**Review of Vermont Yankee
Thermal Discharge Permit Requirements
and Analysis of
Connecticut River Water Temperature and Flow**

August 17, 2012

This report presents a review of National Pollutant Discharge Elimination System (NPDES) thermal discharge permit requirements for the Vermont Yankee Nuclear Power Station and an analysis of water temperature and river flow in the Connecticut River upstream, downstream, and adjacent to the Power Station. The NPDES permit specifies that the temperature rise associated with Vermont Yankee's thermal discharge be calculated using an equation. The equation, referred to as Equation 1.1, is described and its suitability for this application is evaluated and discussed.

Figure 25. Time series of water temperature and river flowrate near the Vermont Yankee Station on the Connecticut River, including USFWS data, June 23 – July 6, 2010 (2 weeks).

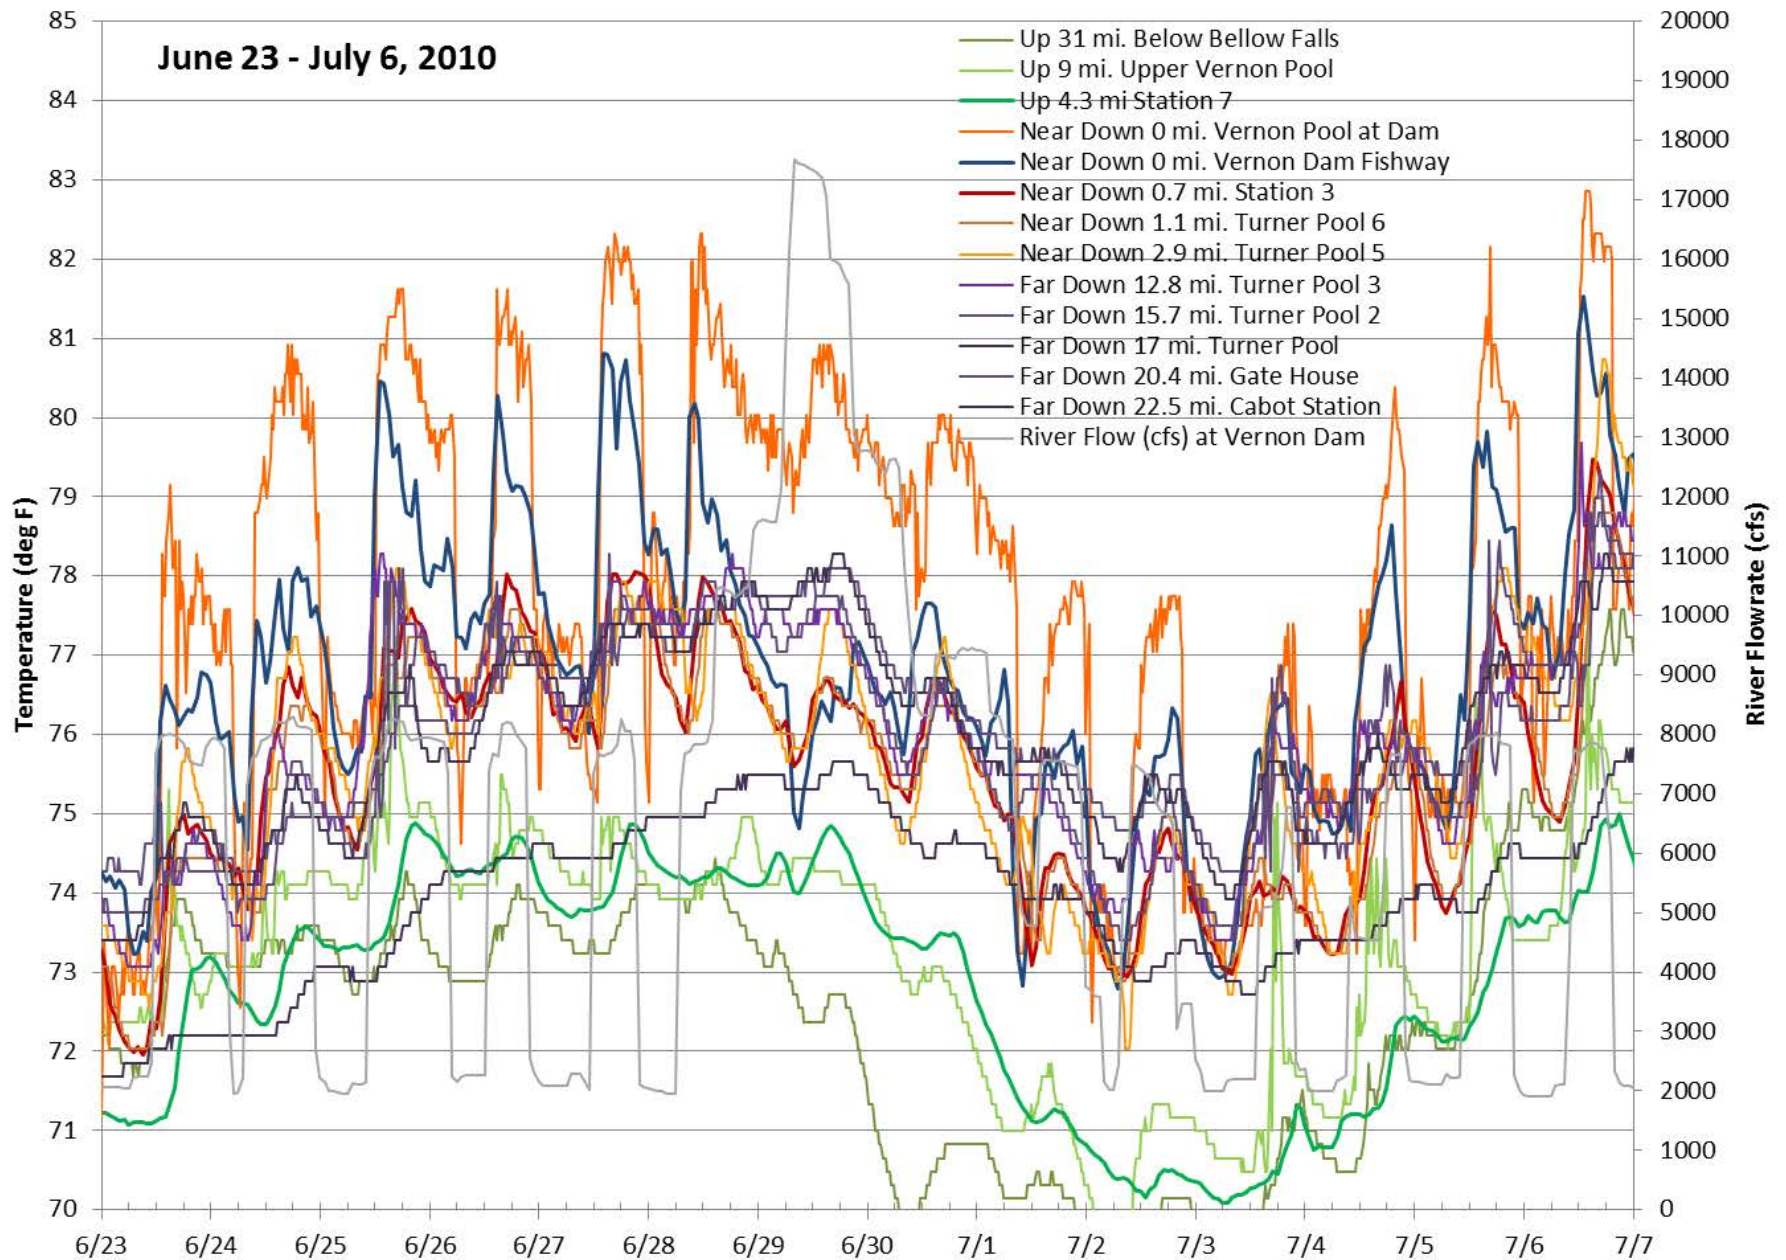
A two-week period from June 23 to July 7 was selected to illustrate water temperature dynamics in the Connecticut River (Figure 25). This time period is presented in two additional figures with some temperature stations removed to make it easier to see individual temperature records associated with far-downstream (Figure 26) and near-downstream (Figure 27) stations. Figure 25 presents all temperature data over a two-week period and illustrates that water temperature varies significantly with flow changes in the river. For example during June 25-28, river flow (gray) varies between 2,000 and 8,000 cfs concurrently with temperature changes at many stations, most dramatically in the Vernon Dam (#43) and fishway locations.

Figure 26. Time series of water temperature and river flowrate near the Vermont Yankee Station on the Connecticut River, featuring downstream USFWS data, June 23 – July 6, 2010 (2 weeks).

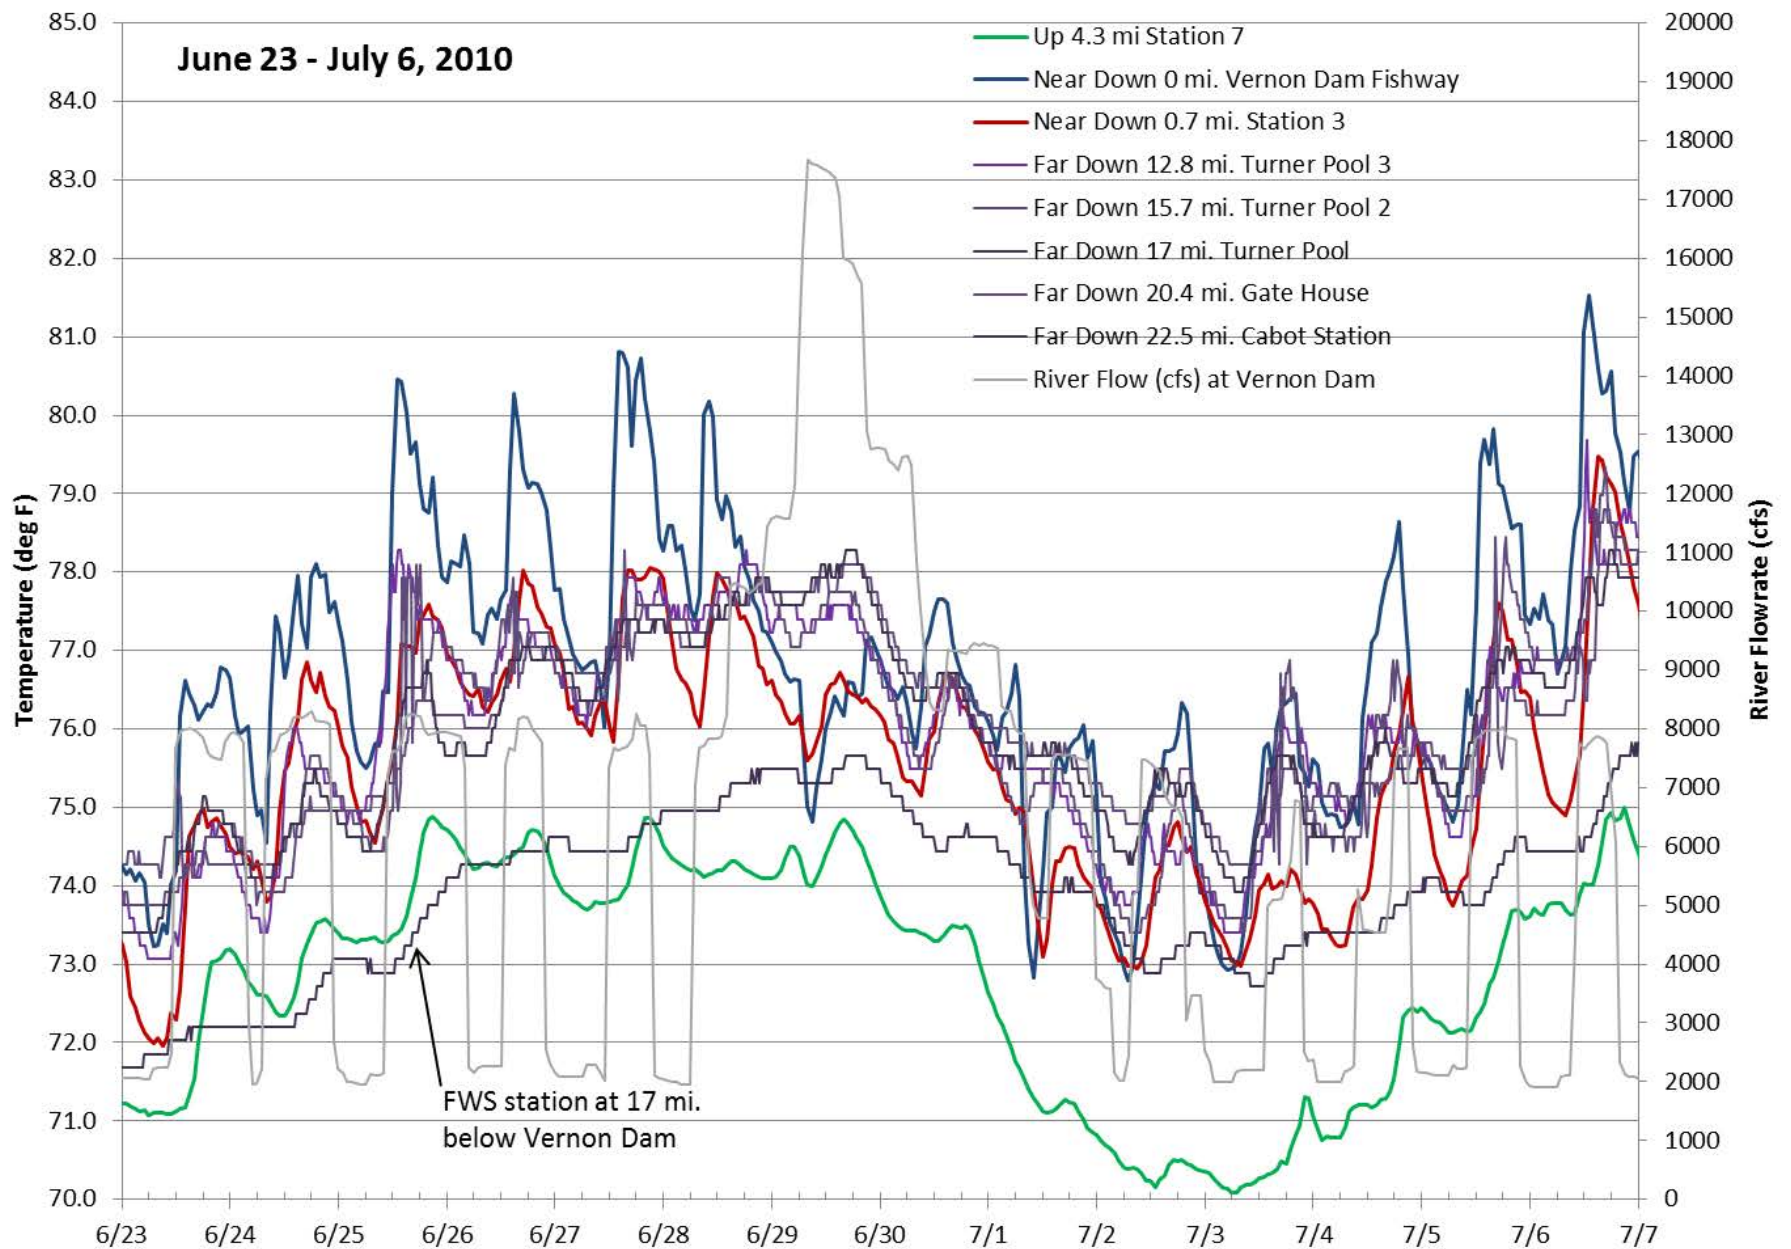
Figure 26 presents the same time period as Figure 25, but without the upstream and near-downstream stations (the Vermont Yankee stations are retained to provide reference values). In Figure 26, the far-

downstream temperature records are more easily evaluated. Of the five far-downstream stations, four are consistently in the same temperature range as Station 3 and the fishway and are warmer than upstream Station 7.

At one of the five far-downstream stations (#51), situated 17 miles downstream, water temperatures are often cooler than those of the other four stations and follow different temporal patterns (see arrow and text in lower left corner of Figure 26). This record can also be observed to be different from the other far-downstream stations in Figures 23 and 24. This sampling location is situated 1.3 miles downstream of another sampling location (#52) and yet the two water temperature records follow very different patterns. River water temperature dynamics can be complex and a variety of factors can affect temperature at each location. At FWS station #51, the description provided by the FWS states that the sensor was placed “Just upstream of deep hole in corner down from cliffs” (Table 5). This passage suggests that the anomalous water temperatures could potentially be due to cooler water associated with the deep hole and inflow of cold groundwater (i.e., seepage).

Figure 27. Time series of water temperature and river flowrate near the Vermont Yankee Station on the Connecticut River, featuring near Vernon Dam USFWS data, June 23 – July 6, 2010 (2 weeks).

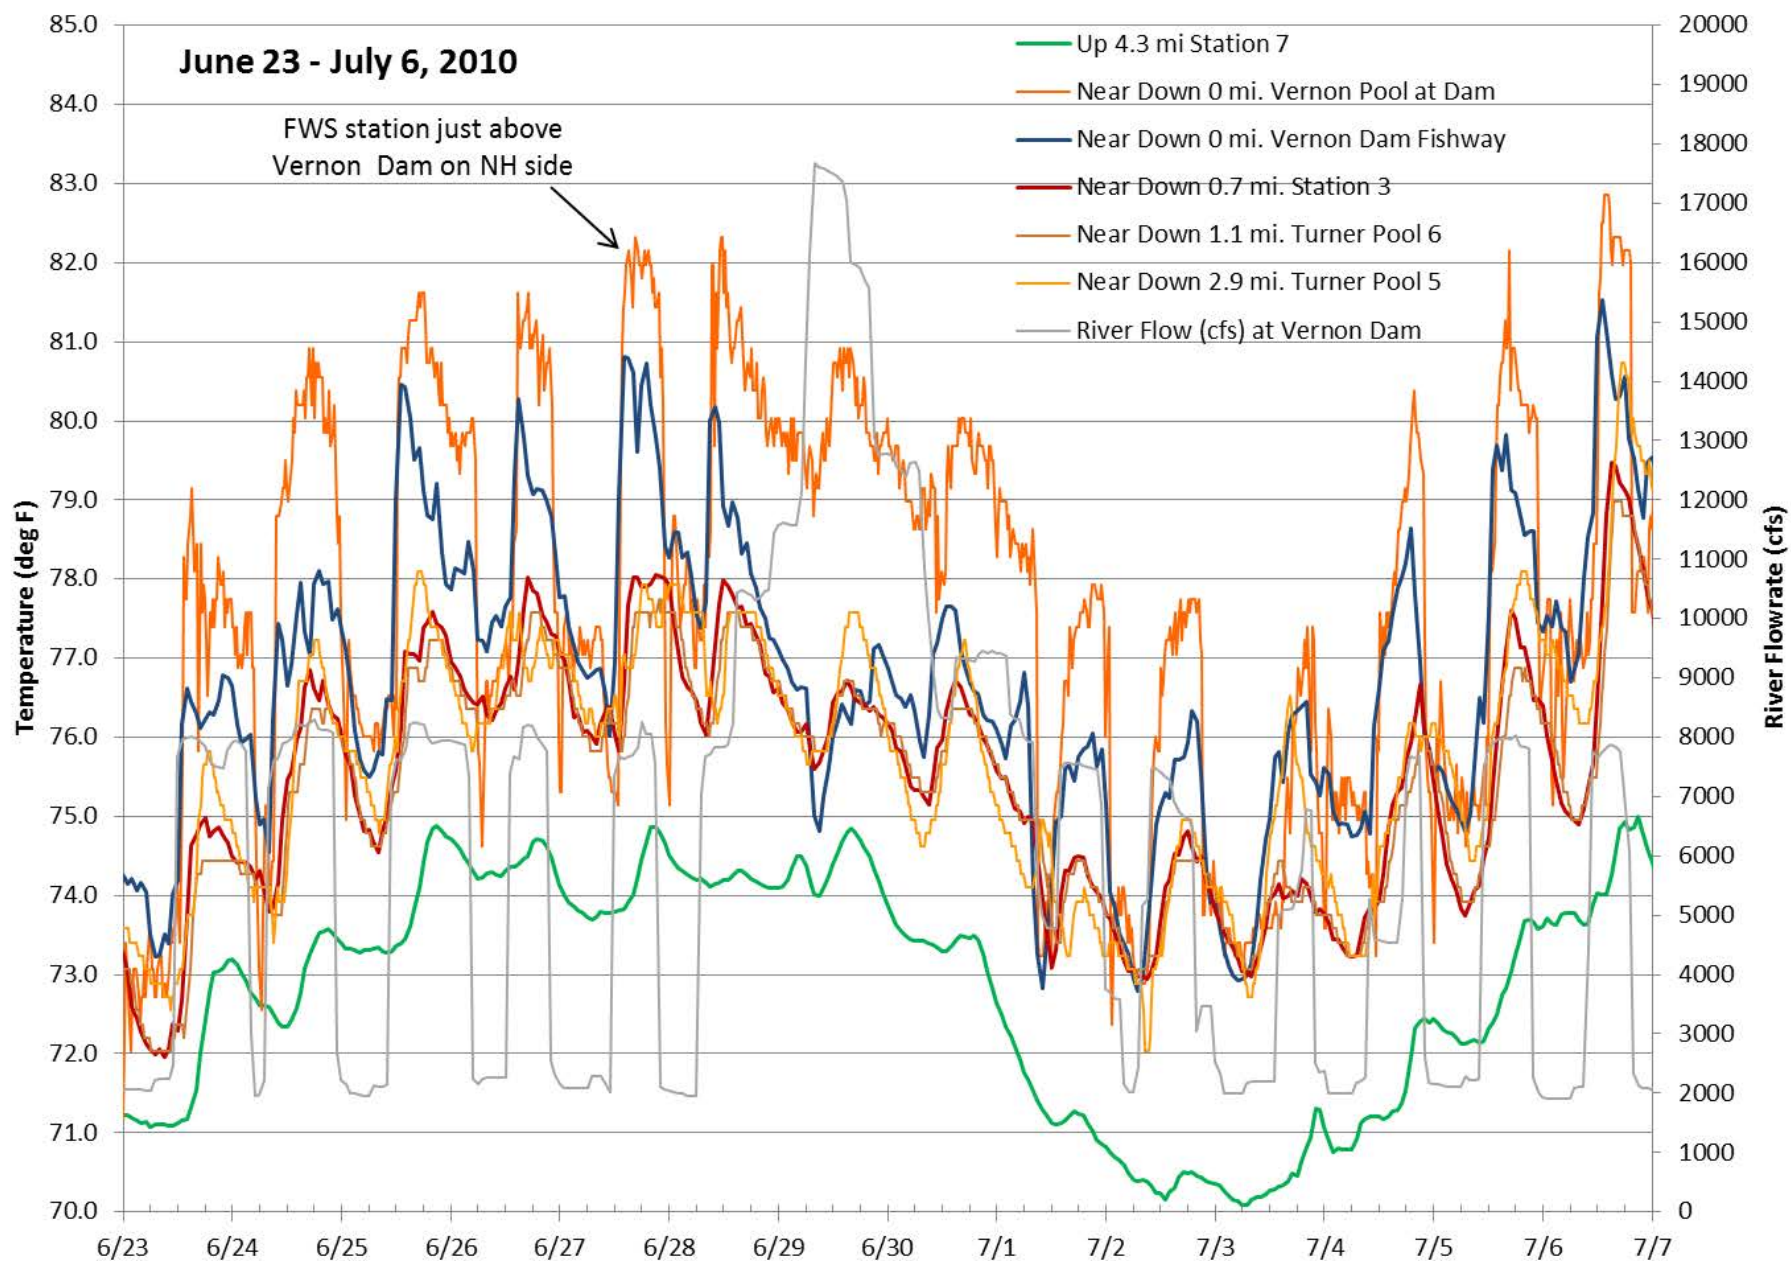
Figure 27 presents the same time period without the upstream and far-downstream stations, enabling analysis of near-downstream data. In Figure 27, the FWS station just above the dam recorded the highest water temperature (labeled in upper left). Each of the near-downstream stations follows a similar temporal pattern of higher temperature during high river flow rate and lower temperature at lower flow rates. This pattern is consistent between the Vermont Yankee stations and the FWS stations during this time period.
